Access Compliance Report

Public Rights-of-Way

Intersection ID: 10035551	Main Street: REA_RD	Cross Street: N/A	Location: SW
ADA ID: 0EBB0FAE299D	Ramp Type: PerpDiag	Initial Pass/Fail: Fail	Overall Compliance: No
Codes/Mitigation Info/Possible Solution		Field Measurements/Component Compliance	
Severity Score: 21.25

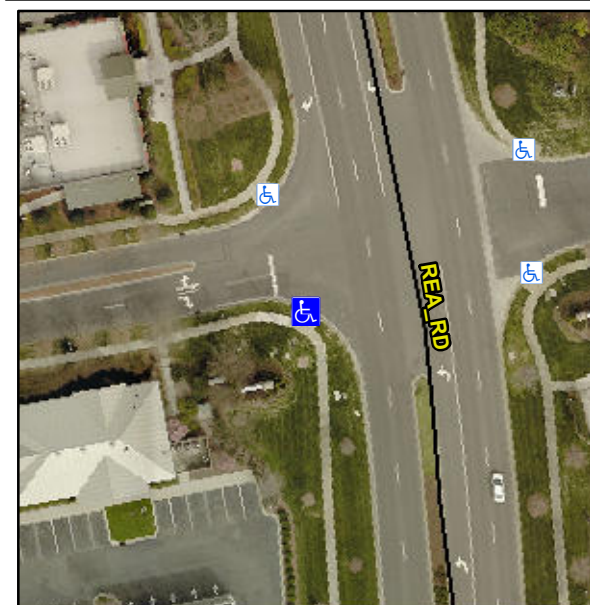
Not Found, R304.5.1, R304.2.2

Compliance	Description	Data	Compliance	Description	Data
N/A	Ramp Length (in)	73.0	No	Ramp Slope (%)	11.6
No	Ramp Width (in)	43.0	Yes	Ramp XSlope (%)	0.6
N/A	Flare Type LT	N/A	N/A	Flare Type RT	N/A
N/A	Flare Slope LT (%)	N/A	N/A	Flare Slope RT (%)	N/A
N/A	Flare Traversable LT?	N/A	N/A	Flare Traversable RT?	N/A
N/A	Landing Length (in)	N/A	N/A	DWS Provided?	N/A
N/A	Landing Width (in)	N/A	N/A	DWS Contrast?	N/A
N/A	Landing Slope (%)	N/A	N/A	DWS Length (in)	N/A
N/A	Landing X Slope (%)	N/A	N/A	DWS Full Width?	N/A
N/A	Landing Curb? (Y/N)	N/A	N/A	DWS Offset (in)	N/A
N/A	Shared Landing?	N/A			
N/A	Gutter Ponding?	N/A	N/A	Gutter Slope (%)	N/A
N/A	Gutter Lip Ht (in)	N/A	N/A	Gutter X Slope (%)	N/A
N/A	Painted X Walk1?	No	N/A	Painted X Walk2?	No
	X Walk 1 Direction	To E		X Walk 2 Direction	To N
N/A	X Walk 1 Width (in)	N/A	N/A	X Walk 2 Width (in)	N/A
	X Walk 1 Slope (%)	2.0		X Walk 2 Slope (%)	2.1
	X Walk 1 X Slope (%)	1.8		X Walk 2 X Slope (%)	3.0

Remove & Replace Curb Ramp With Two New Directional Ramps or Equivalent.
